RE: Correspondence dated 29 April 2020 from File Planning and Development Services P/L about 164 and 170 Croatia Avenue, Edmondson Park on behalf of Super Star Holding Group P/L

We write in response to correspondence from File Planning & Development Services P/L (File Planning) on behalf of Super Star Holding Group P/L (Super Star) dated 29 April 2020, to the Department of Planning, Industry and Environment (DPIE), in relation to Landcom's application (MP10_0118 MOD 5) to modify the Edmondson Park South Concept Plan (Concept Plan) and the *State Environmental Planning Policy (State Significant Precincts) 2005* (Precincts SEPP).

Figure 1: Magnification of the Concept Plan¹, demonstrating the Site Boundary and areas designated as "Town Centre". Note this excludes lands owned by Super Star.

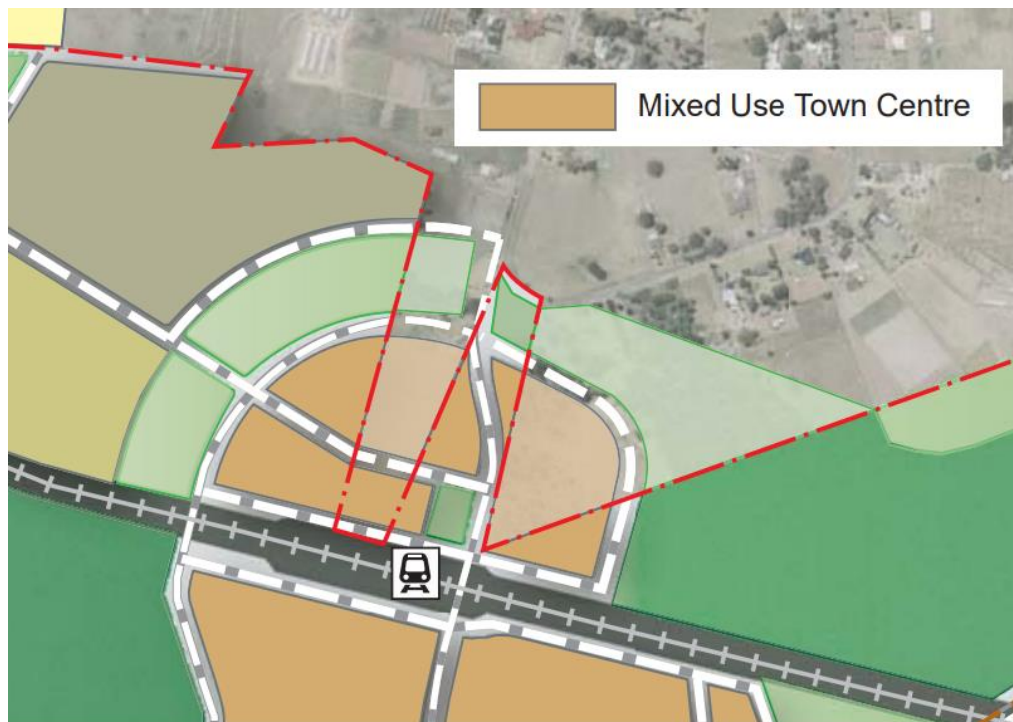
"[...] the approval includes a requirement that a Development Control Plan be prepared for the entire Edmondson Park Town Centre. [...] including the lots outside the Concept Plan area. [...] On this basis we request [Super Star's] site be included in Landcom's proposed modification to the Concept Plan, and be included in their proposed design guidelines.

We assert that the Concept Plan does not apply to land outside of the Concept Plan Site Boundary. At the time of preparing the Concept Plan in 2010-2011, some land outside of the Concept Plan Site Boundary was included in the Precincts SEPP showing suitable land use zones which would support the development of the Edmondson Park Town Centre. The Concept Plan does not require land outside of the Concept Plan Site Boundary be included in any Development Control Plan (DCP) on the basis that the Concept Plan defines the Town Centre as an area as demarcated within the Site Boundary (Error! Reference source not found.).

Importantly, Landcom has an Agreement with Office of Strategic Lands to develop its land, it is not reasonable that Landcom should prepare a DCP over land of which it has no control and no ability to enforce a DCP. Landcom cannot be made responsible for the planning outcomes on sites belonging to other landowners and it is up to these landowners to engage consultants to prepare their own controls by negotiating with the appropriate determining authority. This approach is consistent with that undertaken by Frasers for its town centre development.

Figure 2: Height of Buildings Precinct SEPP Map submitted to DPIE as part of the Response to Submissions, July 2020

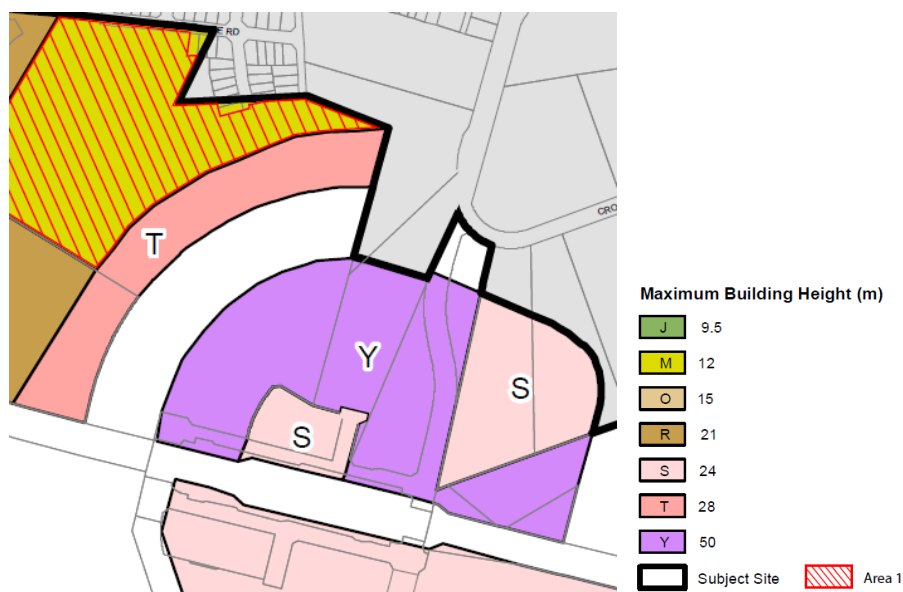
“Landcom’s proposal seeks to increase the maximum height of buildings within the Town Centre to 50m, whilst retaining the FSR of 2:1. Based on the Explanation of Intended Effect for the SEPP Amendment [shows] this height increase is not proposed to be applied to [Super Star’s] Site. However [...] the Concept Plan Environmental Assessment identifies a height of 50m for [Super Star’s] Site. It is appropriate that a consistent height control be applied across the entire northern portion of the Town Centre, including [Super Star’s] site.”

When Landcom responded to the Secretary’s Environmental Assessment Requirements in August 2018, the adjoining Super Star site was erroneously included in the proposed modification to the Height of Buildings Map of the Precincts SEPP, to increase the heights of buildings on the Super Star site. Landcom subsequently submitted a modified Height of Buildings SEPP Map to DPIE which excluded the adjoining Super Star site, but the Environmental Assessment Report was not revised. The revised Height of Building Map, excluding the Super Star site, was the plan which was placed on public exhibition in November – December 2018.

Landcom has subsequently lodged the final Response to Submissions and supporting package of plans and technical studies to DPIE. The Height of Buildings Map below forms part of the Response to Submissions documentation. Consistent with the revised Height of Building Map placed on public exhibition in 2018, the Height of Buildings Map does not include any modifications to the 24m height limit permitted on the adjoining Super Star site.

Landcom does not agree to Super Star’s request to be included in our application to modify the Concept Plan and Precincts SEPP for the purposes of increasing building heights on their land.
